NOTICE OF CHANGE

MIL-STD-1760C
NOTICE 1
2 March 1999

DEPARTMENT OF DEFENSE
INTERFACE STANDARD FOR

AIRCRAFT/STORE ELECTRICAL INTERCONNECTION SYSTEM

FIGURE 2. Primary interface signal set.

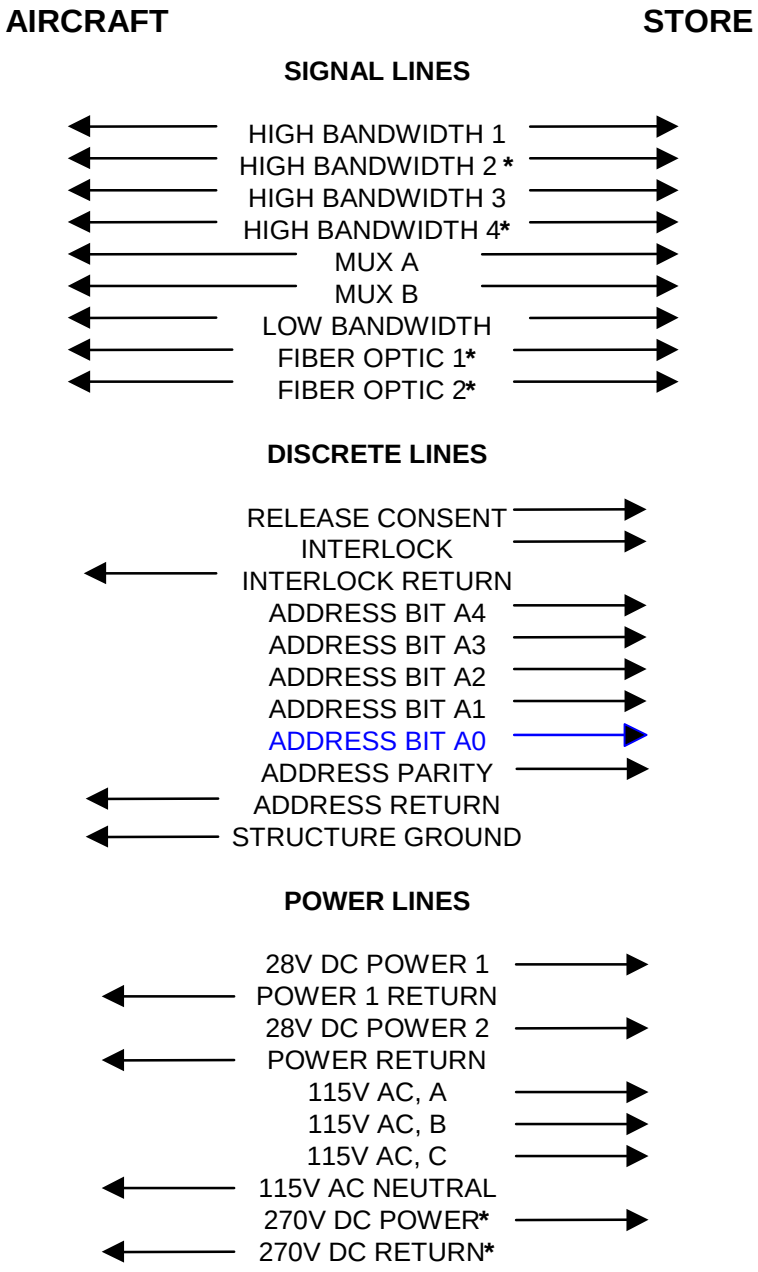
[Note 13a]

Page: 9
[Note13a] Address bit A0 was re-inserted on this figure in notice 1 to correct a typo.

FIGURE 3. Auxiliary power signal set.

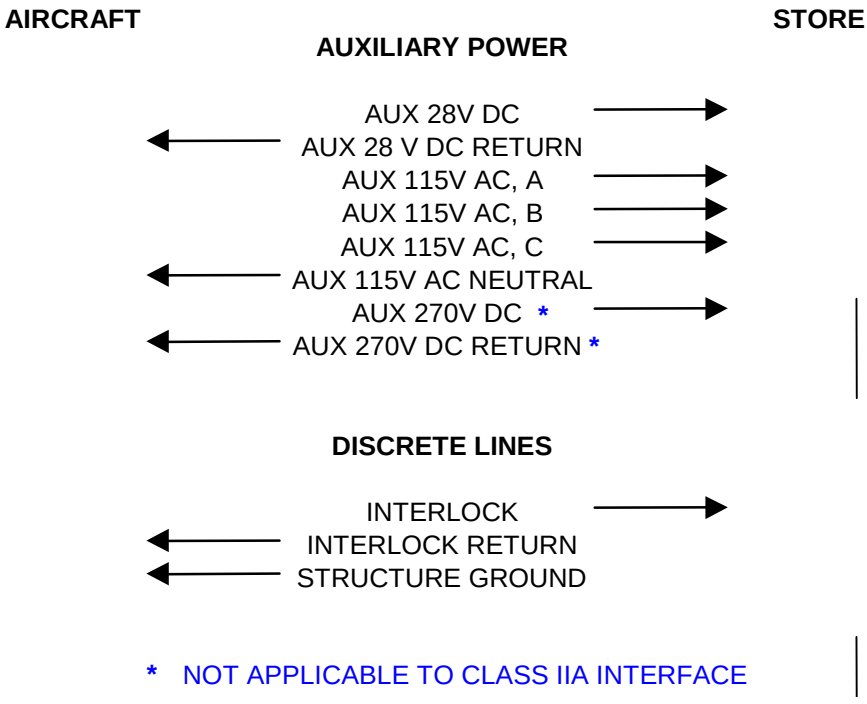
[Note 13b]

Page: 10
[Note13b] Asterisks added in Notice 1 to clarify that 270 V dc power is not included in the class IIA interface.

FIGURE 25. Connector orientation **[Note 86a]**.

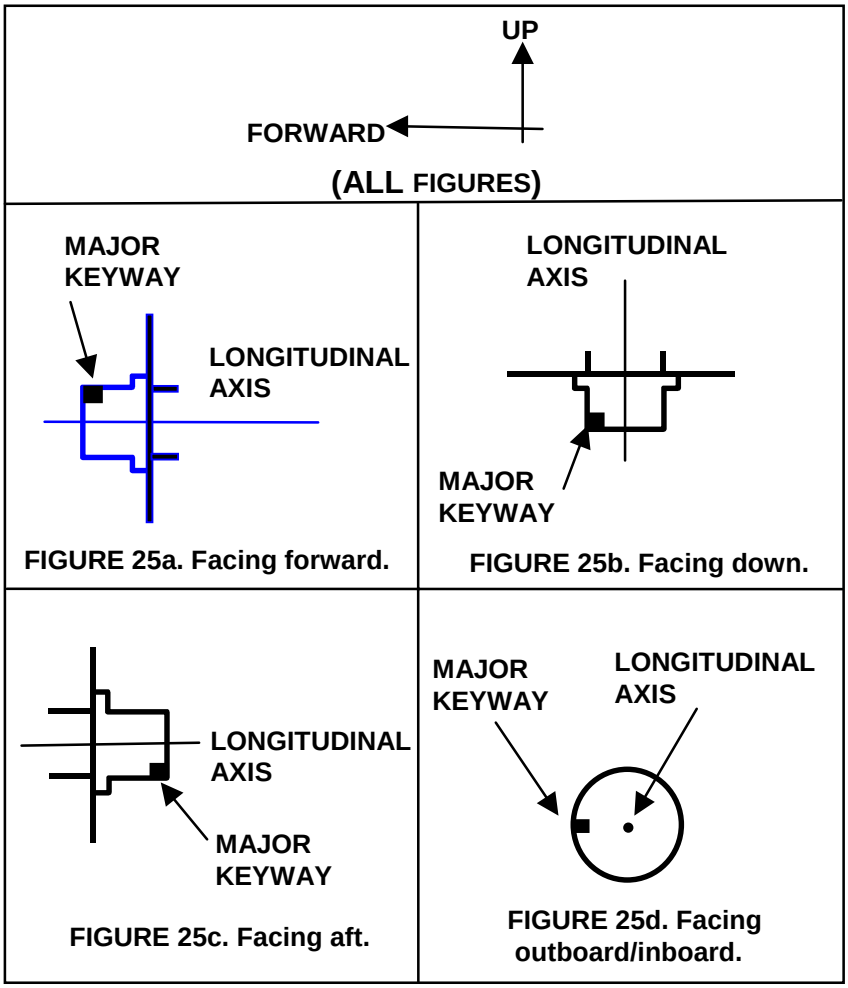
Page: 59
[Note86a] Notice 1 added the lines that were missing from Figure 25a, with no change in the intended requirement.
